# Access Compliance Report

## Public Rights-of-Way

Intersection ID: 5421	Main Street: SUNSET_RD	Cross Street: OLD_STATESVILLE_RD	Location:	N
ADA ID: 4FE00652FBE5	Ramp Type: BlendTrans1	Initial Pass/Fail: Pass	Overall Compliance: No	Severity Score: 0
Codes/Mitigation Info/Possible Solution		Field Measurements/Component Compliance

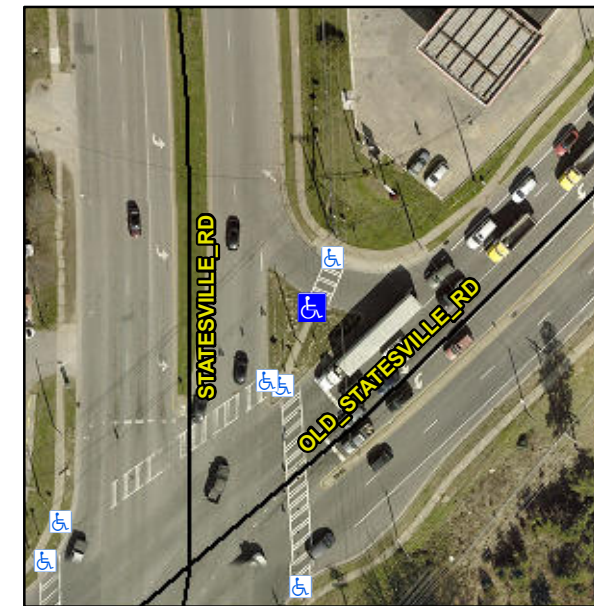
**Remove & Replace Curb Ramp With Two New Directional Ramps or Equivalent.**

**LOCATED ON ISLAND**

**Not Found, R304.2.1, R304.2.2-Perp, R304.3.2-Para, R302.7**
